METROPOLITAN GOVERNMENT OF NASHVILLE AND DAVIDSON COUNTY

STAFF RECOMMENDATION 1808 Sweetbriar Avenue February 20, 2013

Application: Demolition; New construction-primary building
District: Belmont-Hillsboro Neighborhood Conservation Zoning Overlay
Council District: 18
Map and Parcel Number: 10416025900
Applicant: Sandi Adams, Rigid Construction
Project Lead: Sean Alexander, sean.alexander@nashville.gov

FRONT ELEVATION

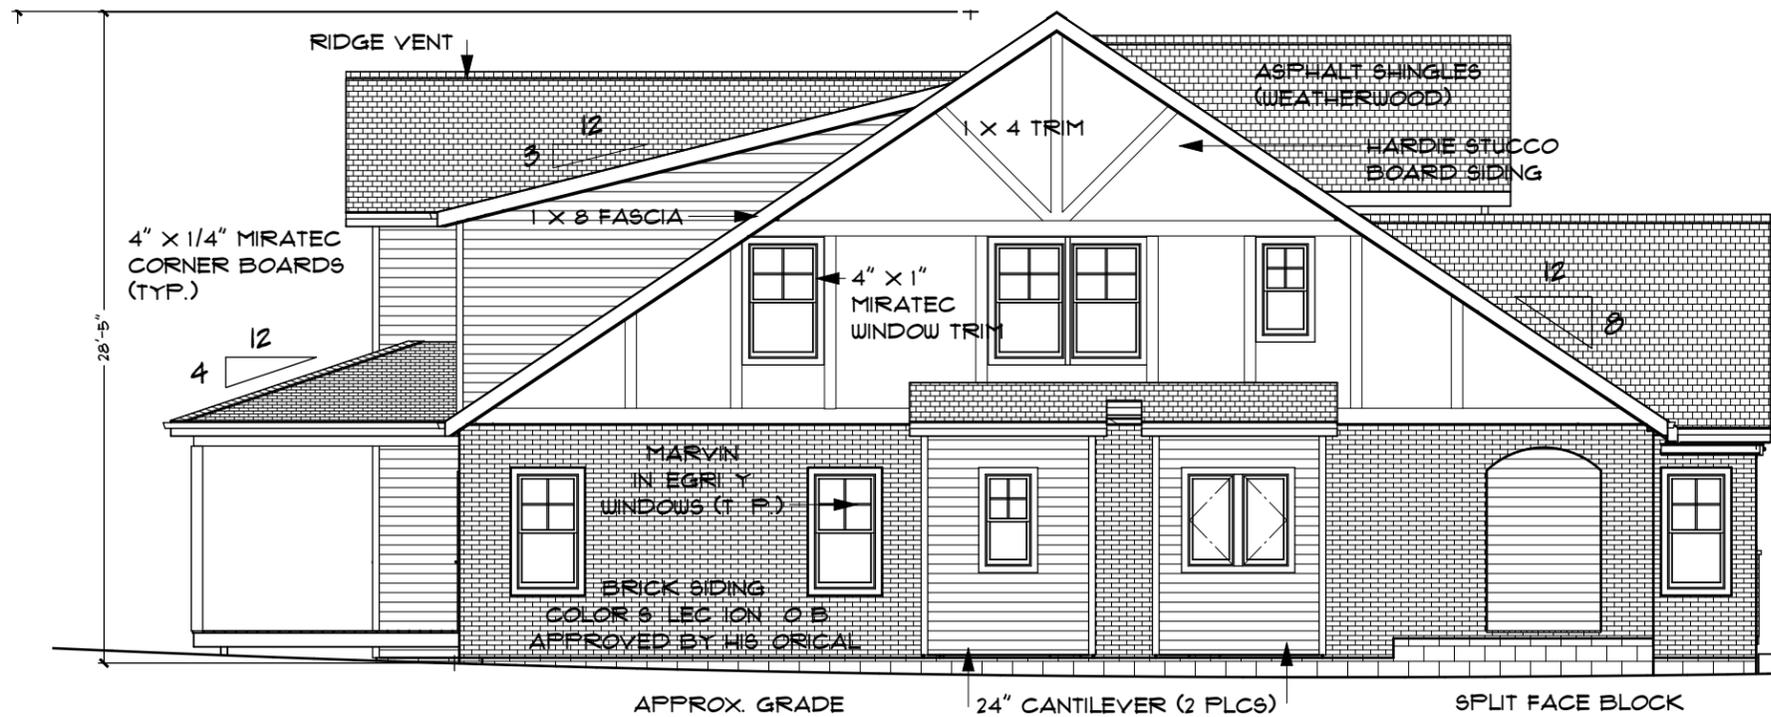
1. The foundation height be uniform on the primary facades of the building;
2. The porch floor slabs be increased to eight inches (8") in thickness;
3. The front porch depth be increased to six feet (6');
4. The window configuration on the front elevation be revised to be more appropriate to the type of window openings found in the district;
5. The windows in masonry walls have typical brick molding;
6. The eave overhangs be extended to eighteen inches (18");
7. Revised drawings be submitted to reflect any and all approved conditions;
8. Staff approve the brick color and texture and the half-timber stickwork; and
9. The lap siding have a minimum reveal of five inches (5").

The foundation height of the house will be two feet (2') which is generally consistent with that of historic houses, with the exception of the foundation on the porches which would be eight inches (8") taller. Instead of having a taller foundation, staff finds that having a uniform foundation height but increasing the thickness of the porch floor slabs to eight inches (8") would be more appropriate. Additionally, staff finds that the front porch depth should be increased to at least six feet (6'), as is typical of historic porches.

The spacing of windows on the front and side elevations on the new building will be asymmetrical but not unlike the window patterns found on historic Tudor Revival style houses. Staff finds the placement of windows to meet guideline II.B.1.g. However, staff finds the configuration of a double window flanked with two sidelights on the front wall (Master Suite on floorplan) to be inappropriate and more typical of an entrance than a window opening. The elevations show wide casing trim around the windows in both the first story masonry walls and the upperstory frame walls. Windows in masonry walls should have brick mold and elsewhere the trim should be four inch (4") flat casings. Staff finds that with a revision of the configuration of the front-left window to something more typical of the rhythm of openings found in the district, and with brick mold used around windows in masonry walls only, the proportion and rhythm of windows will meet guideline II.B.1.g.

1. The foundation height be uniform on the primary facades of the building;
2. The porch floor slabs be increased to eight inches (8") in thickness;
3. The front porch depth be increased to six feet (6');
4. The window configuration on the front elevation be revised to be more appropriate to the type of window openings found in the district;
5. The windows in masonry walls have typical brick molding;
6. The eave overhangs be extended to eighteen inches (18");
7. Revised drawings be submitted to reflect any and all approved conditions;
8. Staff approve the brick color and texture and the half-timber stickwork; and
9. The lap siding have a minimum reveal of five inches (5").

ELEVATIONS 1

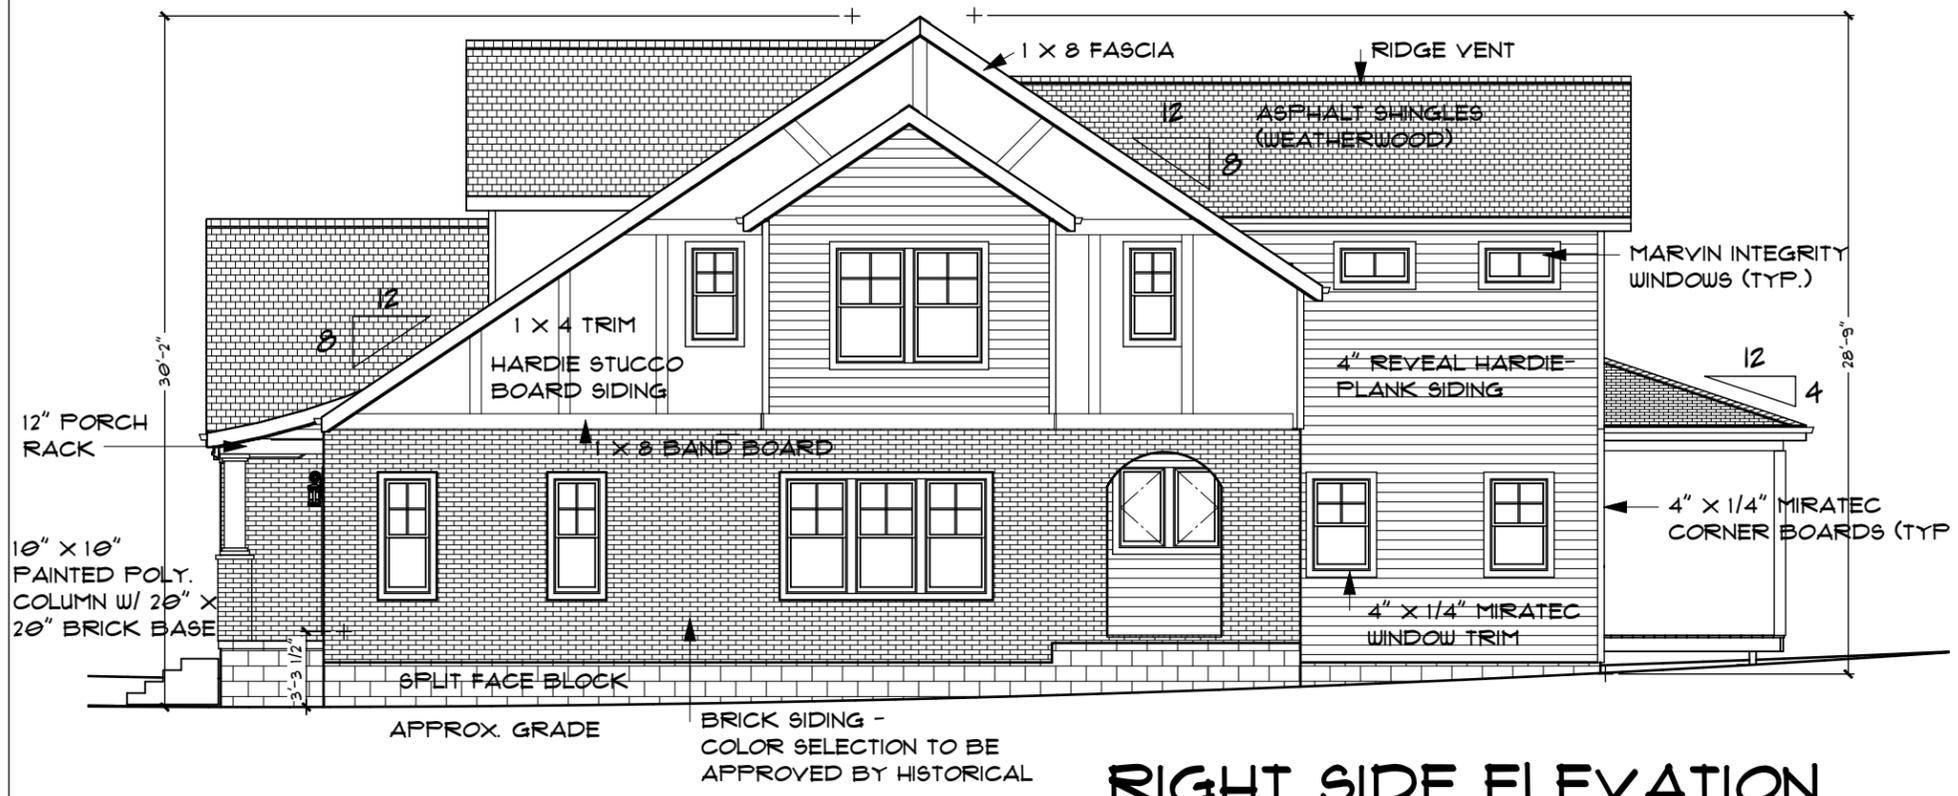
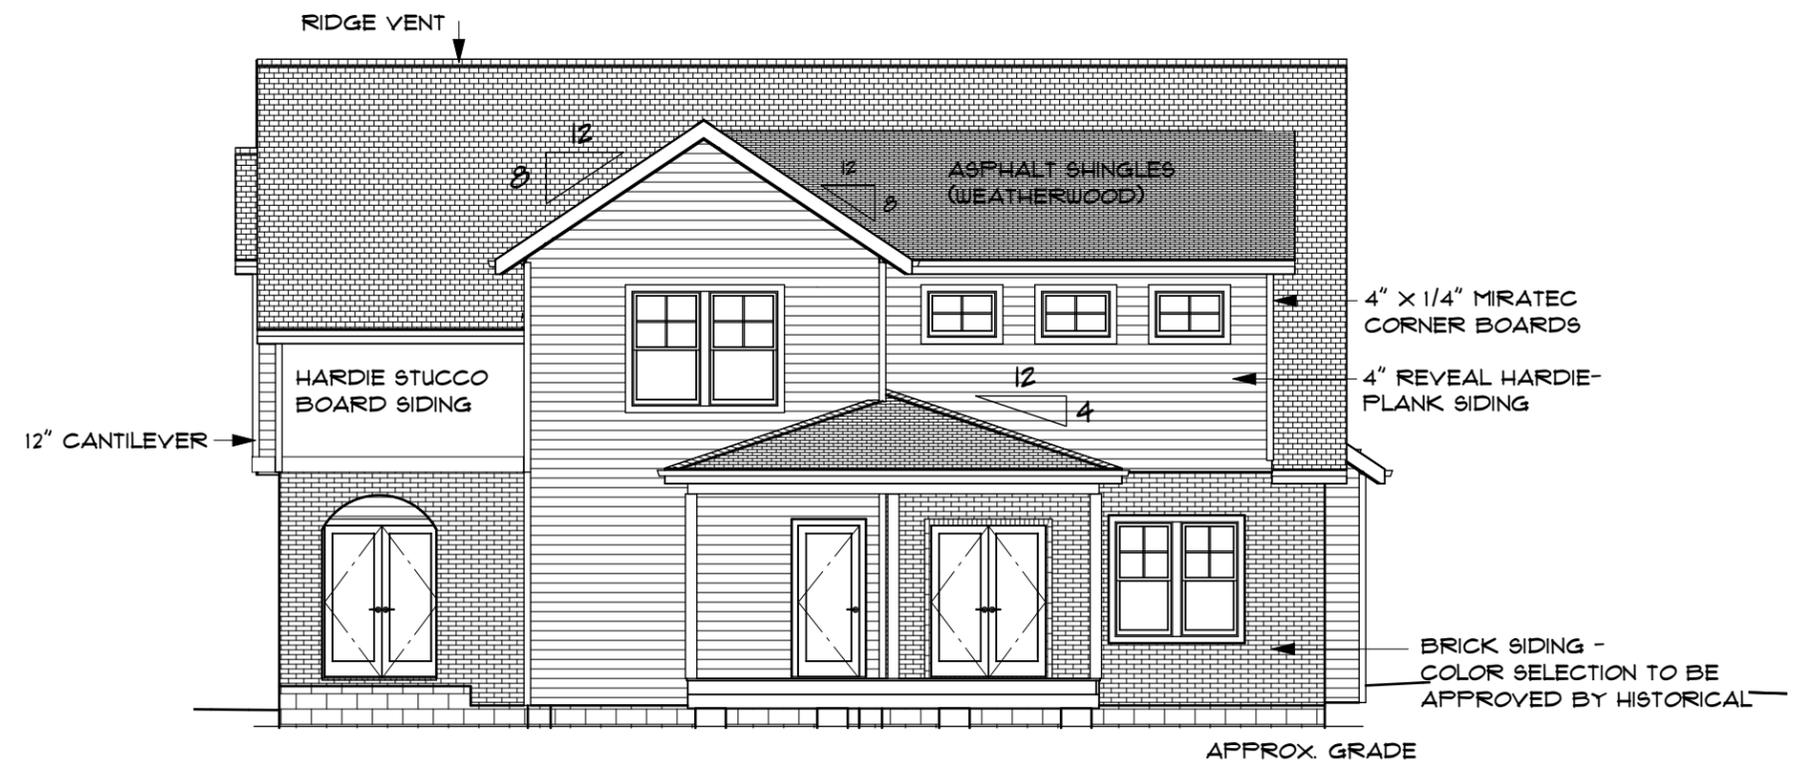
The primary roof of the new house will be a side-facing gable with an 8:12 pitch. A front facing gable on the first story and a front gabled dormer will be steeper at 12:12. These roof forms are common to both Craftsman and Tudor style houses, and are compatible with the roofs of surrounding historic houses. A rear shed dormer with a 3:12 pitch with its sides set in from the outside walls may be minimally visible, but is also appropriate. The eaves of the house would have a twelve inch (12") overhang, which may be similar to the eaves on Tudor Revival style houses but not on Craftsman. Staff finds that an eighteen inch (18") wide eave overhang would be more in keeping with the two style elements present on the proposed infill. *A mix of styles is common, even historically.*

The Commission has typically requested the dormers sit off the ridge by a minimum of two feet (2') and the proposed is only one foot (1') off the ridge.

With the condition that the dormer sit off the ridge by a minimum of two feet (2'), staff finds the roofs would be in compliance with guideline II.B.1.e.
